To: T10 Technical Committee
From: Rob Elliott, HP (elliott@hp.com)
Date: 26 October 2006
Subject: 06-466r0 SAS-2 OPEN_REJECT RETRY during self-configuration changes

Figure 1 — Configuring not complete example

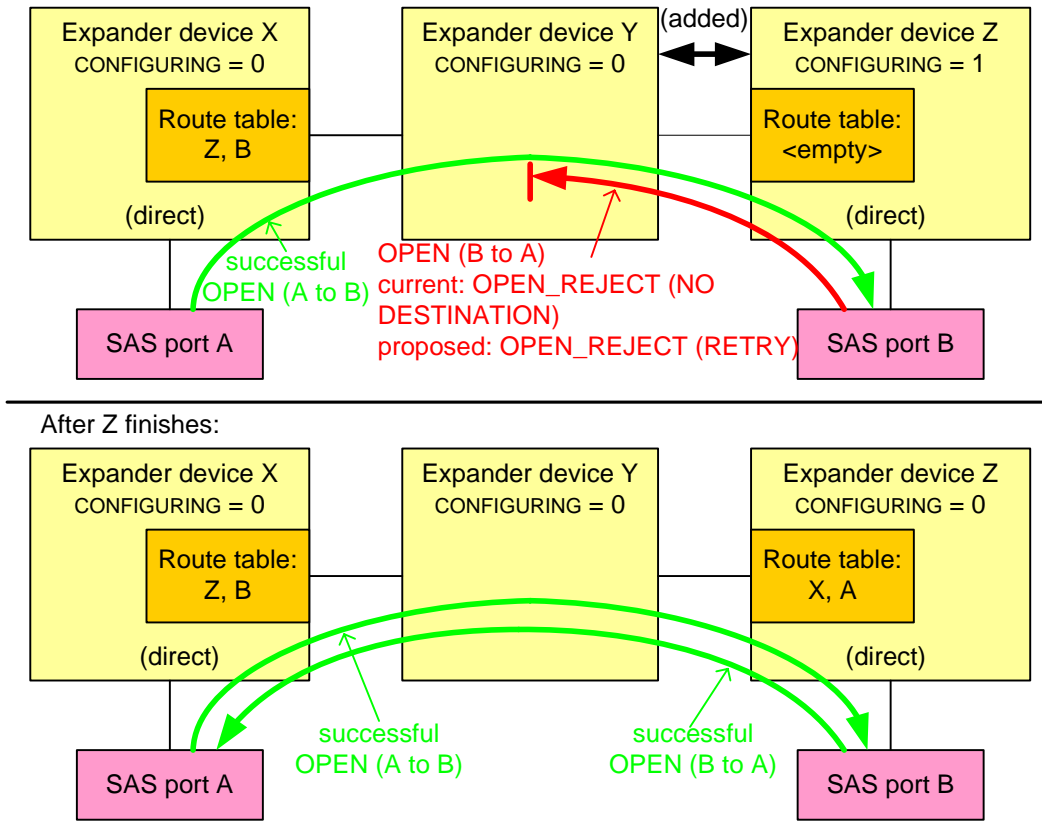
After an initiator performs the discover process and discovers a target, it may start opening connections to that target. If a self-configuring expander along the pathway has not yet put the target's SAS address into its downstream routing tables, the initiator will get OPEN_REJECT (NO DESTINATION). This is not a problem; the initiator also discovers the expanders and should have noticed that one of them has its CONFIGURING bit set to one, indicating that it should extend the I_T nexus loss time indefinitely.

If the downstream route tables are all complete, the initiator could open the target successfully, send a read command (like INQUIRY), and close the connection. However, when the target tries to open the initiator, there is no guarantee that all the expanders have finished self-configuration in the upstream direction, so the target could get OPEN_REJECT (NO DESTINATION). Since targets don't perform the discover process, it doesn't know an expander still has its CONFIGURING bit set to one and that it should extend its I_T nexus loss time. If self-configuration takes too long, it will declare an I_T nexus loss (unless the initiator happens to open it in the meantime).

After expander Y and Z are attached, assume X and Y complete self-configuration quickly while Z is slow:

Zoning expanders return OPEN_REJECT (RETRY) rather than OPEN_REJECT (ZONE VIOLATION) while zoning configuration changes are in progress. Self-configuring expanders could do the same, and return OPEN_REJECT (RETRY) rather than OPEN_REJECT (NO DESTINATION) if self-configuring changes are in progress.
